Town of Mammoth Lakes

Advisory Design Panel Staff Report

February 1, 2024

AGENDA TITLE: Advisory Design Panel meeting for consideration of Major Design Review Application #DR 24-001, for the “Regal Peaks” development project located in the Resort General zoning district of the North Village Specific Plan Area. The project consists of a 5-story “Resort Condominium” development with a total of 198 rooms within 118 condominium units. The Major Design Review application process incorporates Advisory Design Panel (ADP) review to provide impartial feedback regarding significant new development project conformity with applicable design guidelines.

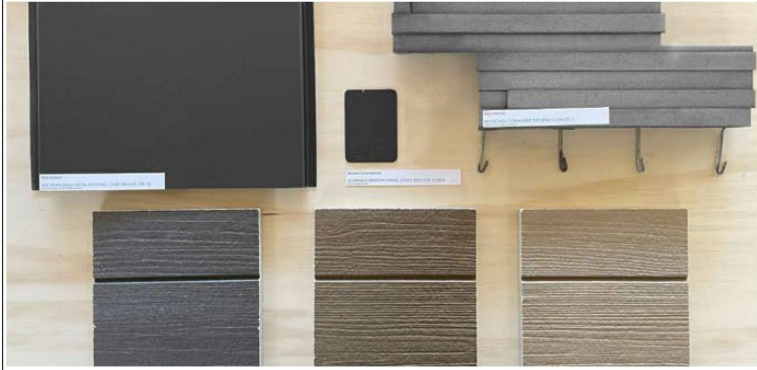
1. The proposed walkway design should be a meandering path rather than the severe zigzag design, and the pathway should connect to the woodland garden feature so that this feature is not an island that is only accessible from the public sidewalk.
2. The architecture no longer incorporates details that evoke alpine chalet or craftsman architectural style.
3. The roofline has an industrial appearance and dominates the upper-level balcony.

4. The color palette appears cooler in tone with the change to gray concrete base material color and elimination of the earthy red accent color.
5. The windows on the tower features are reduced in size rather than enlarged.
6. The additional towers with flat roofs emphasize the building height rather than breaking it down.
